MEDIC UPDATE
TECHNICAL SERVICE BULLETIN

| SUBJECT: LOW FUEL WARNING LIGHT | | | No. TSB-03-13-007 |
| | | | MODEL: 1997-2003 Diamante |

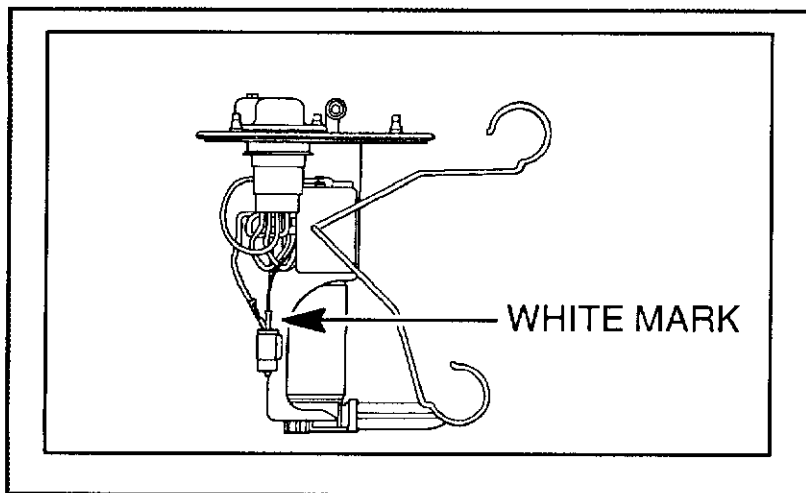
Improved parts have a white mark located above the lower fuel warning thermistor.
